# PRODUCT CHANGE NOTIFICATION

## Bourns® Model CDSOD323-Txxx Series TVS Diode Arrays

### *Additional Assembly and Test Manufacturing Location*

ESD2256REV2

## Typical Part Marking

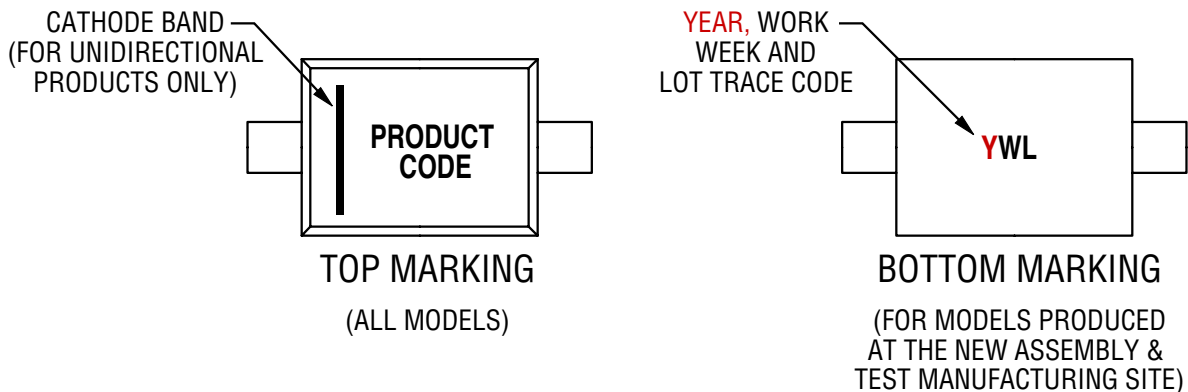
The bottom part marking will be used to identify units produced at the new assembly and test manufacturing site. **The bottom marking will include the Year, (Y), Work Week (W) and Lot code (L) in alphabetic characters while the current existing site will use only the top part marking.**
